### River Bend Station - Unit 1 Docket No. 50-458

Enclosed for your review (Enclosure 2) are revisions to the River Bend Station Final Safety Analysis Report (FSAR) Section 6.2 and Appendix 6A. Enclosure 1 provides a discussion of each of these revisions including their effect, if any, on the Safety Evaluation Report. No revisions of the proposed Technical Specifications are expected to be required. These FSAR revisions will be included in a future amendment.

#### ENCLOSURE 1

QUENCHER AND STRUT ANCHOR LOADS

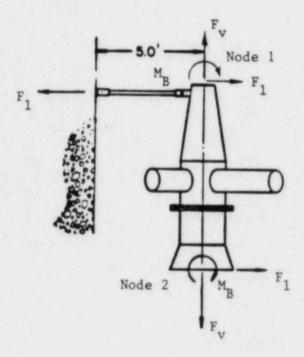
- G. Information designated as "later" in Tables A.6A.7-1 and A.6A.7-2 and Figure A.6A.7-3 has been provided. This information is not expected to affect either the SER or the proposed Technical Specifications.

MAXIMUM QUENCHER ASSEMBLY REACTION LOADS AND MAXIMUM QUENCHER/SRVDL INTERFACE LOADS (Reference Fig. A.6A.7-3)				
	Interface Loads (Node 1)	Reaction Loads (Node 2)	Strut 1	Strut 2	
THERMAL					
F1	6902	38736	28850	32241	
Fv	10428	10428	•		
MB	22323	324162			
MT	8101	12793			
SRSS (OF	BET, OCCU)				
F <sub>1</sub>	45286	63288	36778	40679	
Fv	46561	181839			
MB	17862	372324			
M <sub>T</sub>	5019	105758			
SRSS (OF	BEI, OCCE)				
F <sub>1</sub>	45346	77923	35045	39586	
Fv	46454	181856			
MB	19448	389493			
MT	5738	107556			
	SEI, OCCF)				
Fl	45357	77944	35063	39613	
Fv	46460	181858			
MB	19468	389852			
$M_{\rm T}$	5768	107568
